**DATE:** May 2, 2017

**TITLE:** **LinkedIn Campus Redevelopment – 700 and  
800 East Middlefield Road and 1100 West  
Maude Avenue**

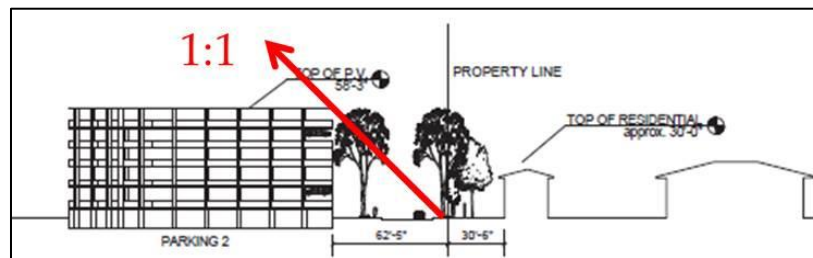
The proposed project includes an increase in building heights up to six stories (or approximately 100') for new office buildings and up to five levels (or approximately 50' to 60') for new parking structures over the existing 1- and 2-story building heights (currently 25' to 40'). The proposed building heights and placement align with input from the East Whisman Precise Plan visioning process for higher-intensity office, with up to six stories in height and preferred location adjacent to freeways. The increased heights allow for smaller building/structure footprints and greater open space on site.

Commissioners unanimously supported the building and parking structure heights proposed in the project.

*CITY COUNCIL QUESTION 3A: Does Council agree with the EPC that 6-story building and 5-level parking structure heights are appropriate for the project?*

### **Proposed Parking Garage Setback**

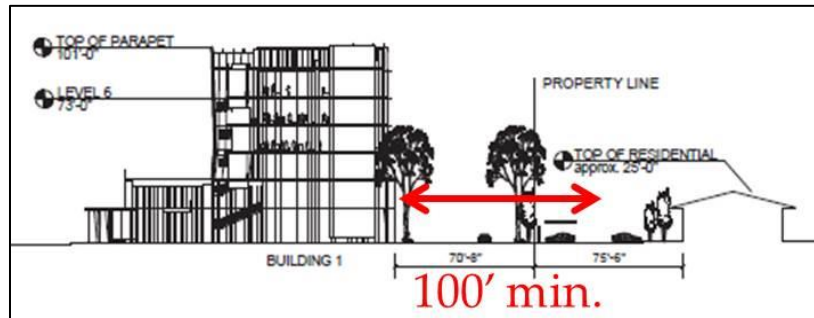
The current office buildings along the eastern portion of the project site are approximately 65' from the shared property line with residential buildings. While one of the office buildings will remain in this location (EP02), the new parking structures are proposed to be set back 57' (Parking 1) and 62' (Parking 2) from the property line and the new office building (Building 1) is proposed to be 80' from the property line. Thus, the new building and parking structures along the eastern project edge will have similar setbacks, or greater, than the current buildings.

More specifically, the parking structures are close to a 1':1' height-to-setback ratio (or 45 degree height setback, as required in the El Camino Real Precise Plan) with 1' in height increase for every 1' set back from the property line. The residential buildings in Sunnyvale have a range of setbacks from the property line of approximately 10' (for a portion of units along the northeast edge near Parking 2) to 75'. Staff believes a minimum parking structure setback of 1':1' height-to-setback ratio may be appropriate for the project site as it permits adequate space for landscape and structure screening, with photovoltaic panels given a height exception as they are a sustainable feature of the project. If Council supports this setback for parking structures, minor modifications to the site plan will be required.

By 7-0 straw vote, Commissioners felt the building and parking structure setbacks seem reasonable for the project, but directed the applicant (and staff) to consult residential neighbors as part of the project outreach process.

*CITY COUNCIL QUESTION 3B: Does Council support a 1':1' height-to-setback ratio for parking structures along a shared residential property line and a minimum 100' building-to-building setback between office and residential buildings for the project?*

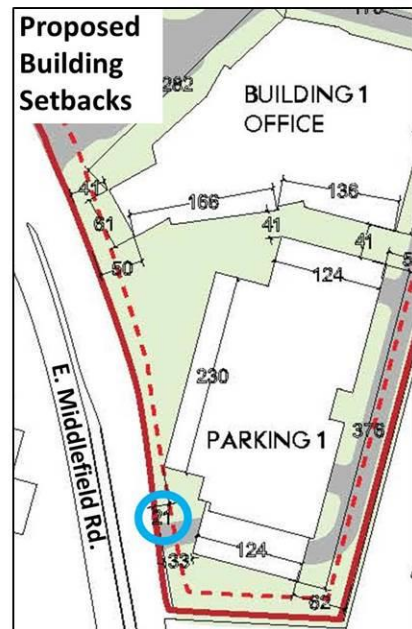
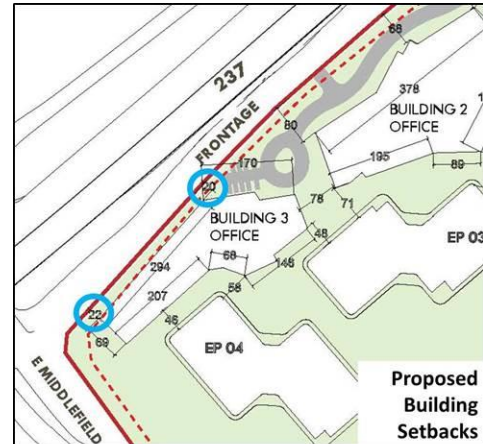
The five existing office buildings have setbacks from adjacent public streets that vary from approximately 150' to 200' to Maude Avenue and Middlefield Road, respectively. While staff supports locating buildings closer to the street to improve street presence, staff is concerned with the proposed proximity of Building 3 (at 20') to the SR-237 Frontage Road and Parking 1 (at 21') to Middlefield Road (see graphics on following page and Sheet A36 of Attachment 4).

As part of the project, City staff will request new separated sidewalks and bike improvements along all three street frontages, which may require placing a portion of these improvements on the project site. With these improvements, the building and parking structure may be located less than 20' from the back of sidewalk along both street frontages. Staff would like the applicant to study alternative site designs that pull back the building and parking structures from the street, which may include reshaping the building/structure footprints or floor plans, and/or pulling Building 3 closer to adjacent buildings (while still meeting building and fire codes). If supported by Council, City staff would work with the applicant to review alternative designs through the development review process, in coordination with the City's Development Review Committee (DRC).

Commissioners unanimously supported having the applicant study design alternatives to allow for greater setback relief. However, Commissioners noted that the modifications should not result in reducing the amount of open area on-site.

*CITY COUNCIL QUESTION 4: Does Council agree with EPC direction for the applicant to study alternative designs for Building 3 and Parking 1 to increase setbacks from the public streets?*

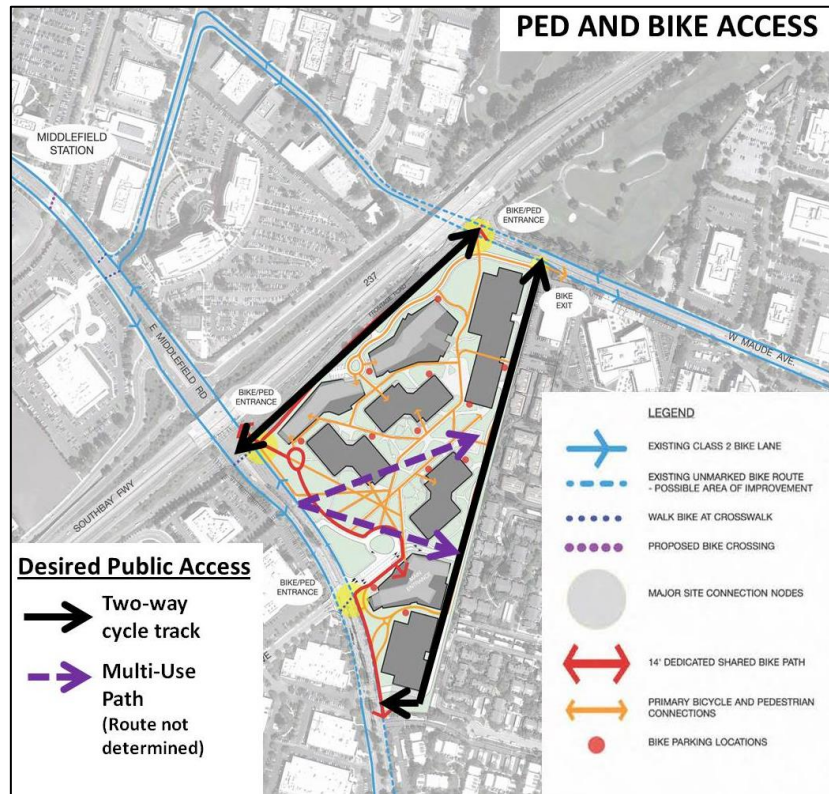
For this project, City staff has identified key pedestrian and bicycle improvements on the project site or frontage, which would improve: (1) access to the site from the VTA light rail; (2) public circulation around the perimeter of the site; and (3) improve connections into Sunnyvale. These improvements include (see graphic on following page):

- *Cycle Tracks (shown in black)*—Provide buffered/separated two-way cycle tracks connecting Middlefield Road and Maude Avenue along the project frontage at the SR-237 Frontage Road with a separated sidewalk, and along the east side of the new perimeter driveway aisle;

- *On-Street Bike Lanes (shown in blue)*—Upgrade on-street bike lanes along the project frontage on Middlefield Road to a buffered on-street bike lane per the City’s 2015 Bike Transportation Plan Update, with a new separated sidewalk; and include new on-street bike lanes and separated sidewalks along Maude Avenue consistent with the City of Sunnyvale’s bike improvements; and

- *On-Site Multi-Use Path (shown in purple)*—Provide two multi-use public paths for pedestrian and bicyclists through the project site allowing connection from Bernardo Avenue (which may connect with a planned undercrossing in Sunnyvale at Evelyn Avenue/Central Expressway), and from the Middlefield Road/VTA Station to Maude Avenue in Sunnyvale. The exact locations of the paths are not identified at this time.

Commissioners unanimously supported these on-site pedestrian and bicycle improvements for the project. One Commissioner noted support for the bicycle

improvements along the eastern edge of the project site, even if it means potential loss of landscaping and/or trees.

*CITY COUNCIL QUESTION 6: Does Council agree with EPC's support of the identified on-site pedestrian and bicycle improvements for the project, or are alternative connections (or improvements) desired?*
